# SLIM CHICKENS SITE PLAN

PARKER AND PINE FILING NO. 1, LOT 3

SITE PLAN  
**SLIM CHICKENS**  
SWC OF S. PARKER ROAD AND E. PINE LANE, PARKER, CO 80134  
**COVER SHEET**

SITE PLAN

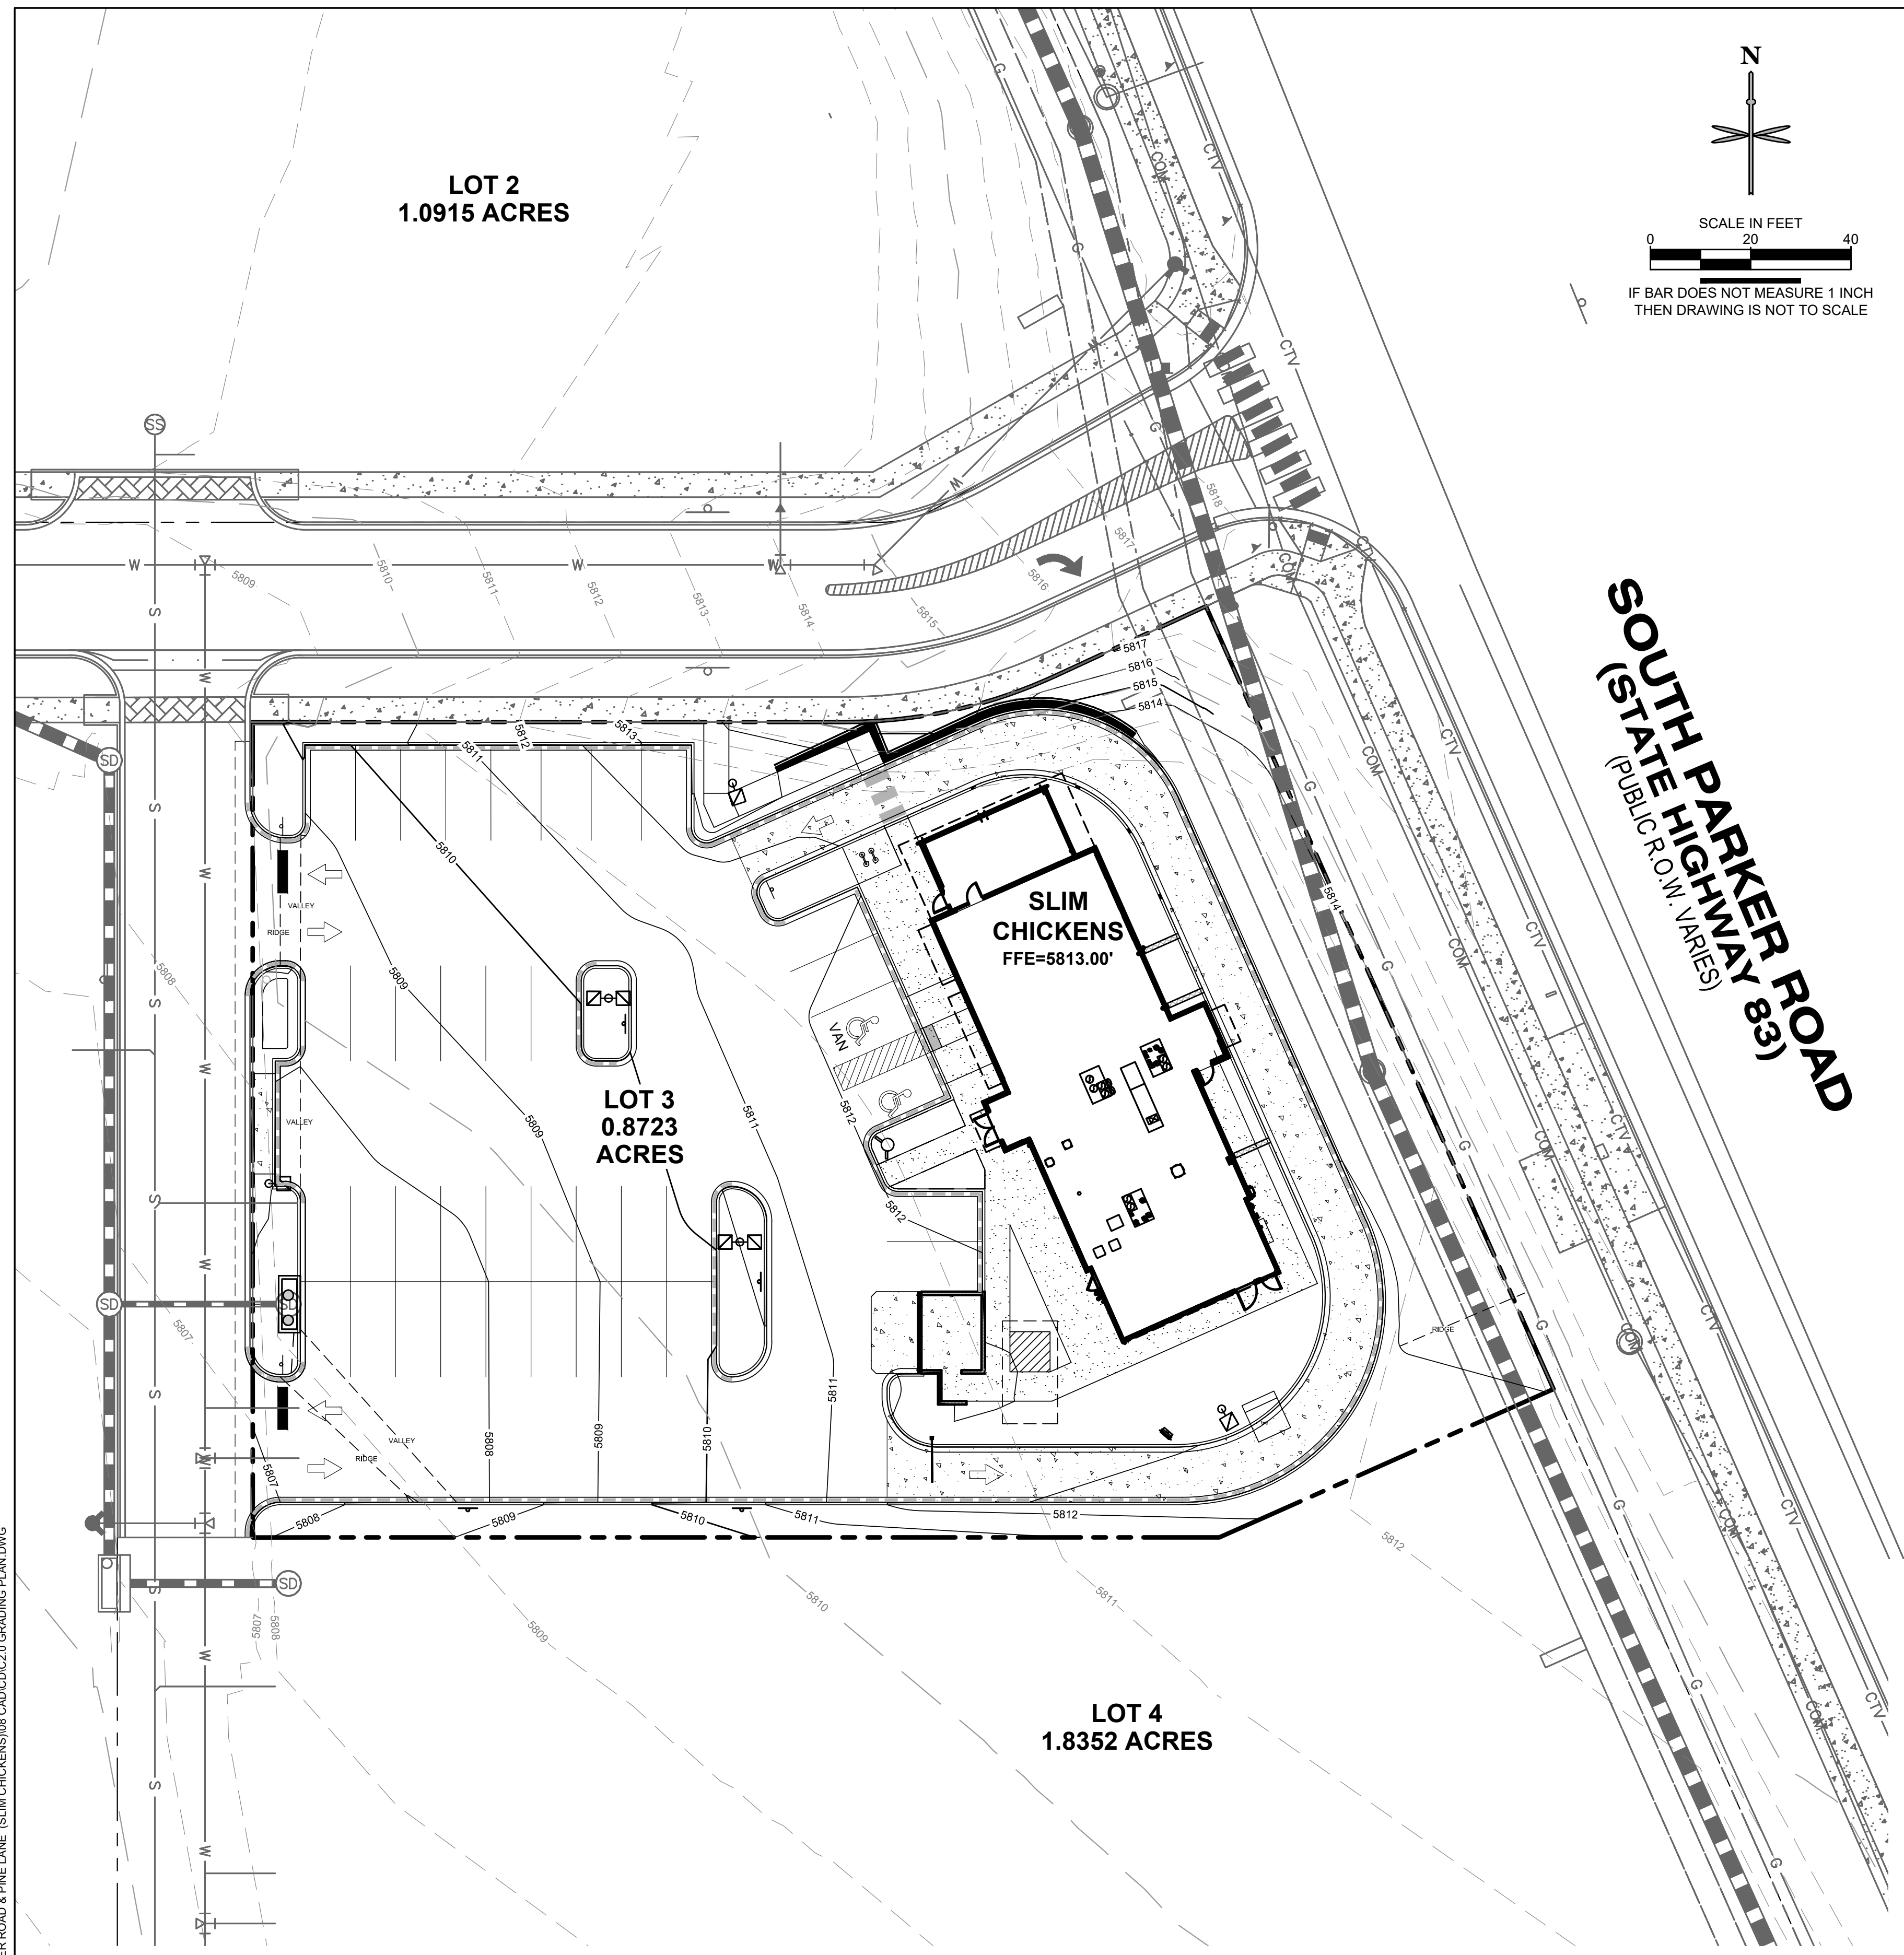
- 1 MASTERPLAN ADA RAMP TO REMAIN
- 2 8' WIDE SIDEWALK TO BE BUILT BY MASTER DEVELOPER
- 3 ~~PROJECT MONUMENT SIGN TO REMAIN, TO BE BUILT BY MASTER DEVELOPER~~   
 It is okay to denote 'future monument & sign locations, but please add "by separate sign permit"   
 Addressed.

- 4 MASTERPLAN STORM INLET
- 5 MASTERPLAN STORM MANHOLE TO REMAIN
- 6 MASTERPLAN SANITARY MANHOLE TO REMAIN
- 7 MASTERPLAN FIRE HYDRANT TO REMAIN
- 8 CROSSWALK STRIPING   
 If this is referring to the real estate sign or future signage, then n/a & please remove. Greenfield and therefore no existing signage. See comment 3. Addressed.

Drive-through screen wall has been shortened and should wrap around to match corner of building at a minimum - as depicted on 1st submittal.   
 **This is not a screen wall. It is a retaining wall.**   
 Enhanced screening is required on this elevation per the approved Preliminary Site Plan due to adjacency to Parker Road - as discussed during that process & requirements for enhanced buffering/screening via landscape walls, landscaping, architectural details, etc.   
 **See revised Landscape Plans.**   
 Please describe how your combined techniques achieve enhanced screening of the drive-through along the Parker Road elevation.   
 **See revised Landscape Plans.**   
 LANDSCAPE SCREENING BUFFER

Per conversations with Town regarding the Preliminary Site Plan process, please provide an entrance canopy at drive-up window.   
 **See revised Building Elevations.**

Please add sidewalk dimension **Completed.**   
 Please add sidewalk dimension **Completed.**

Please add sidewalk dimension **Completed.**

7.83' **8' Streetscape Completed.** required   
 Please add dimension **Completed.**   
 Pls provide setback from property line to building **Completed.**

Please add s.f. to islands area to show compliance with size requirement (162 s.f.). **Completed.**

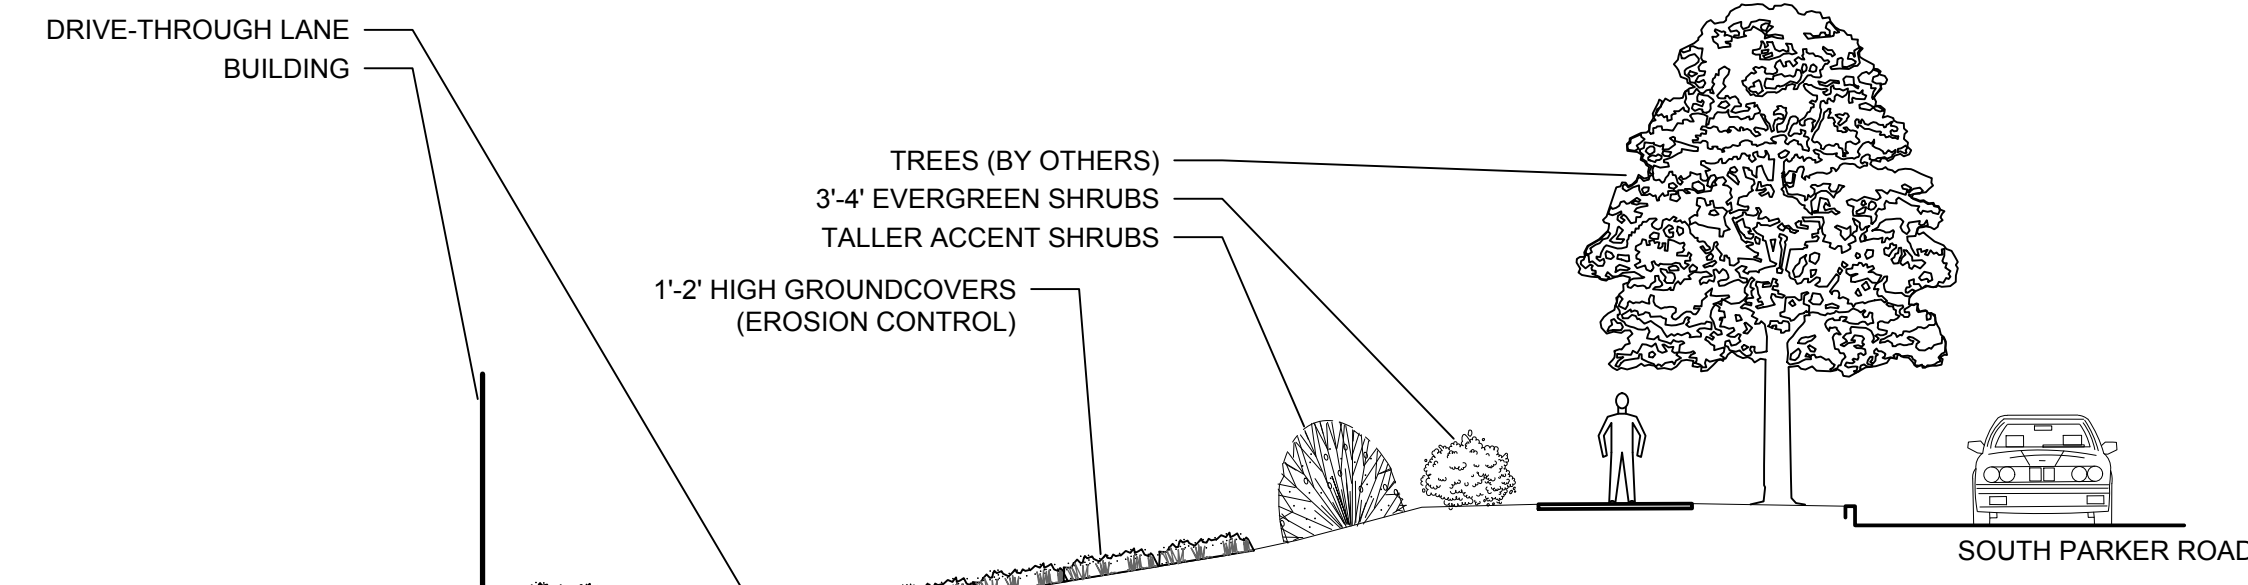
Please callout rock type & color (e.g. 2" granite, 4" white cobble)

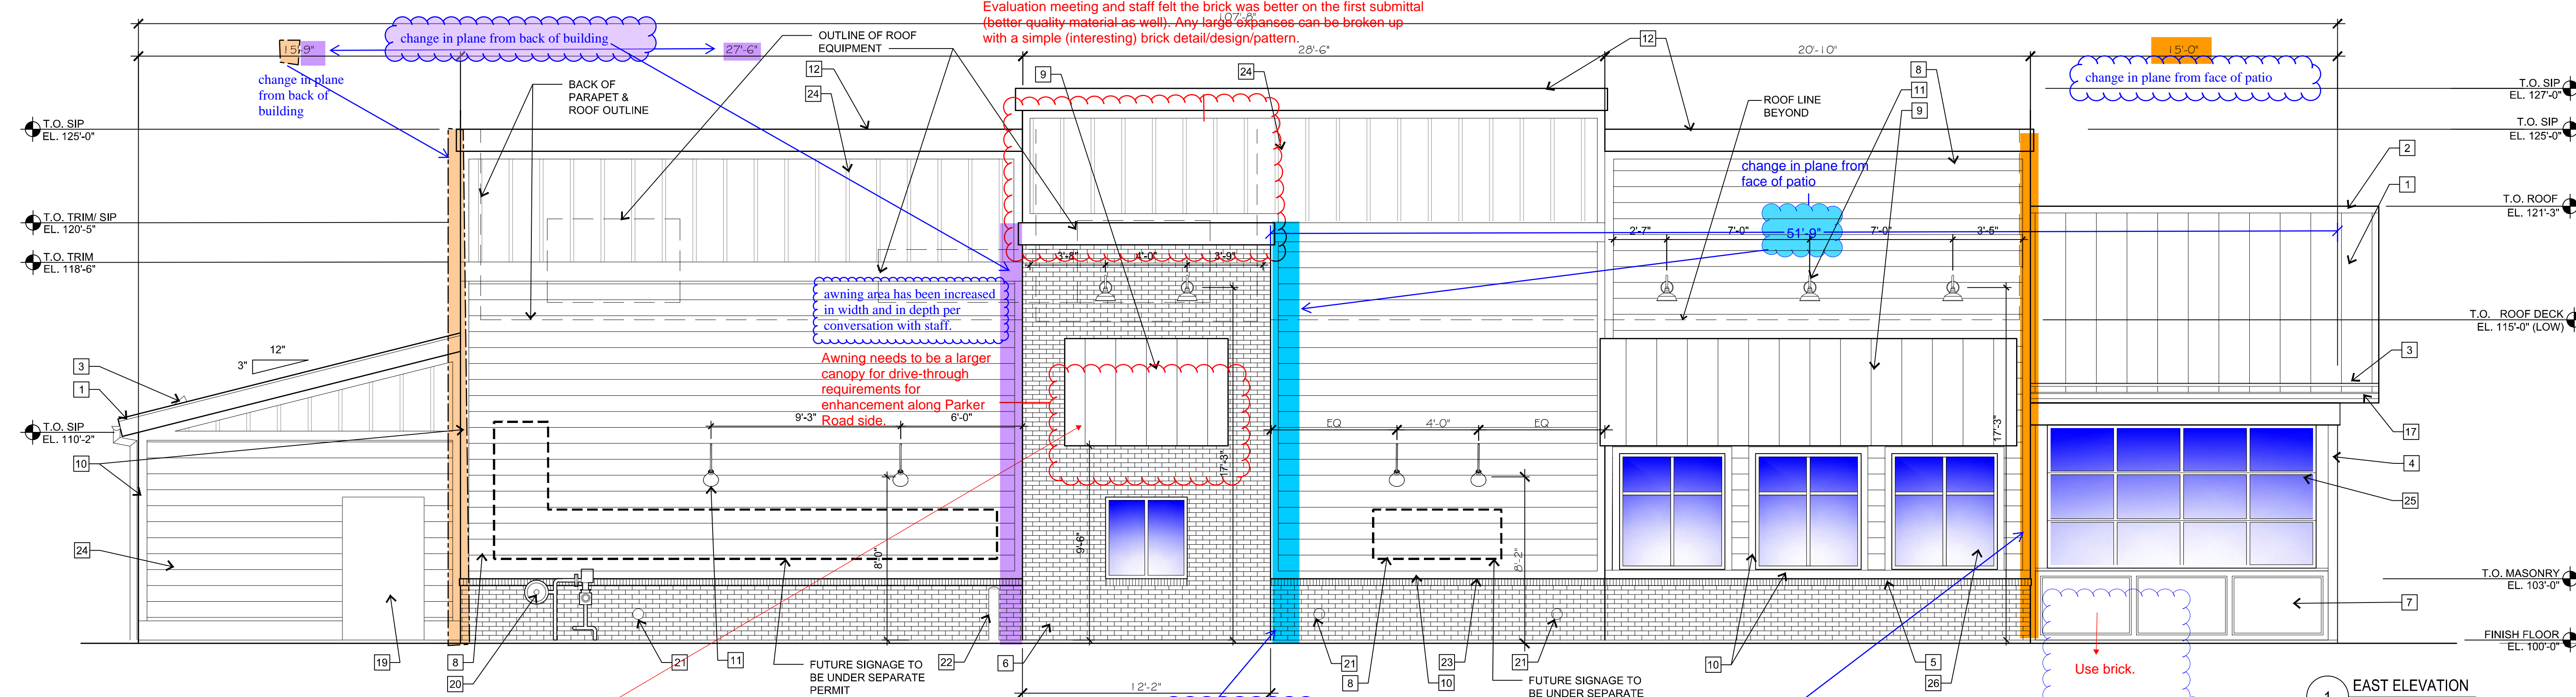
**\* Development Design Standards VIII. Site Design Standards, section F.c.:** When Drive-through windows and facilities cannot be designed to avoid adjacency to public roadways, they shall be covered with a canopy that is integrated into the design of the building and screened with landscaping with an opacity of 80% at one (1) year maturity, a maximum of three (2) feet in height, or screened by a decorative solid wall with a maximum of four (4) feet in height. Please describe how this requirement will be met.

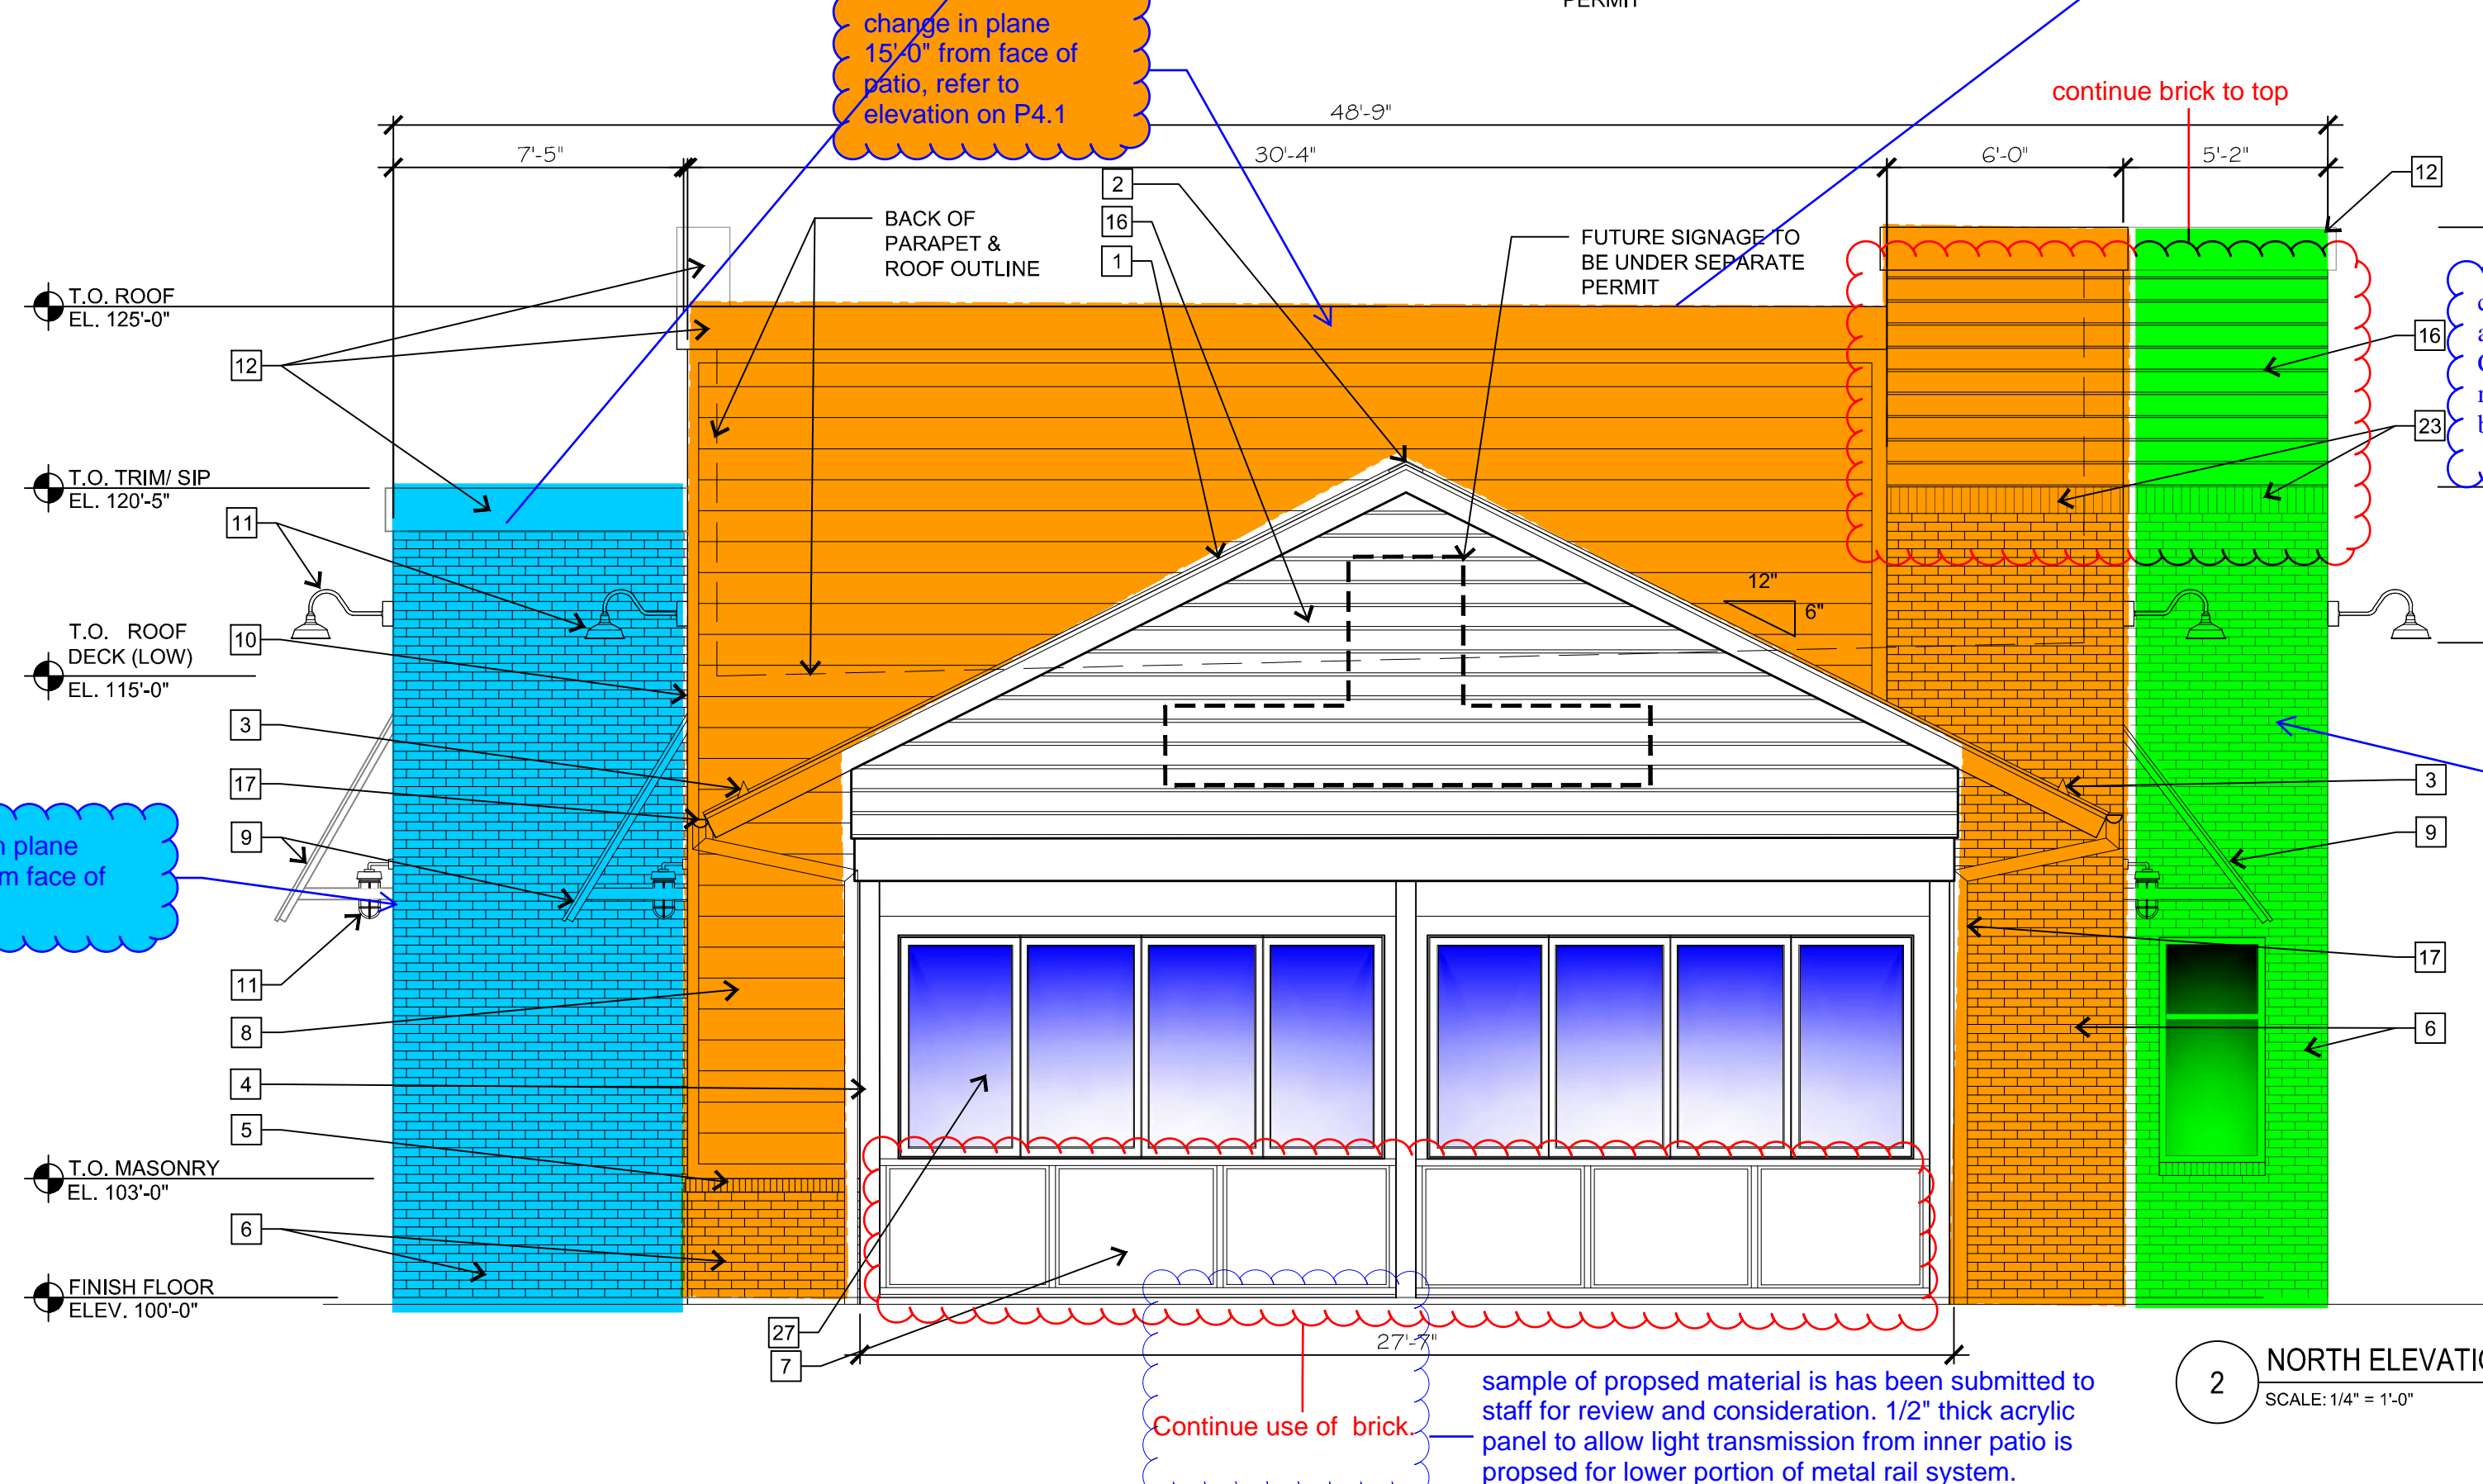
sample of proposed material is has been submitted to staff for review and consideration. 1/2" thick acrylic panel to allow light transmission from inner patio is proposed for lower portion of metal rail system.
